PROPOSED LAYOUT OF STANDALONE TRANSFORMER ROOM FOR LUNG KONG ROAD KOWLOON CITY

Section 16 Planning Application for Proposed Public Uility Installation (Transformer Room) at N.K.I.L. Nos. 3739 RP (Part) and 4064 RP (Part), Lung Kong Road, Kowloon, Hong Kong Planning Application No. A/K10/277

- Submission of Further Information 1 -

Application No. A/K10/277

LAYOUT PLAN OF TRANSFORMER ROOM AT G/F

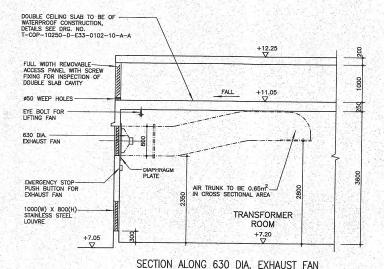
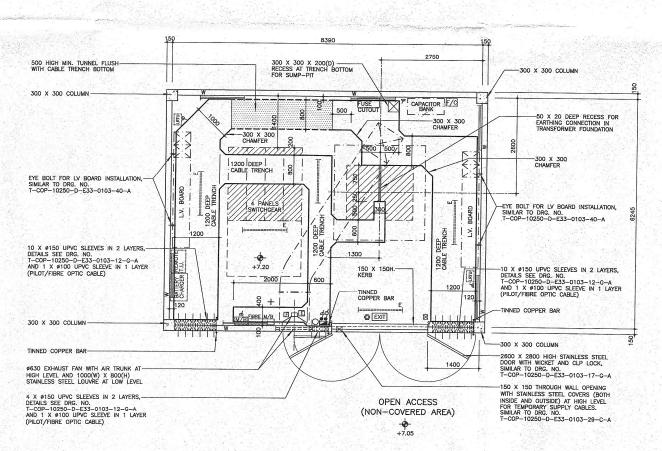
Departmental Comments	Responses
1. Comments from Transport Department (TD)	
Received via email from TP/K10, DPO/K dated 11 December 2024	
1. Currently, there is no vehicular access to the subject site fronting Lung Kong Road. The applicant shall amend part 8 of the Application form accordingly. The applicant shall clarify whether a vehicular access is proposed under the subject application. If affirmative, some existing on-street parking spaces will be affected by proposed vehicular access. The applicant shall obtain agreements from relevant stakeholders, including but not limited to, relevant District Council Members, nearby building owners, shop owners/operators, and nearby institutions for the proposed relocation of the affected onstreet parking spaces. In addition, please make sure the proposed location of the parking spaces complies with TPDM.	Please be clarified that there will be no vehicular access to the subject site. Please find the enclosed replacement page of the application form.

2. Comments from Architectural Services Department (ArchSD)	
Received via email from TP/K10, DPO/K dated 11 December 2024	
In order to enable use to comment on the visual impact of the development, it would be useful to have some photomontages of the proposal in its surrounding context from different vantage points.	The application is intended solely for the proposed transformer room, which is for indicative purposes only and subject to change at detailed design stage. Photomontages of the proposal in its surrounding context may be misleading to the public as they do not accurately represent the final design of the project and its surrounding context. Given the small scale and the proposed development parameters do not deviate from the statutory planning restrictions, no visual disturbance will be generated by the proposed development. Therefore, photomontage is deemed unnecessary for the submission.
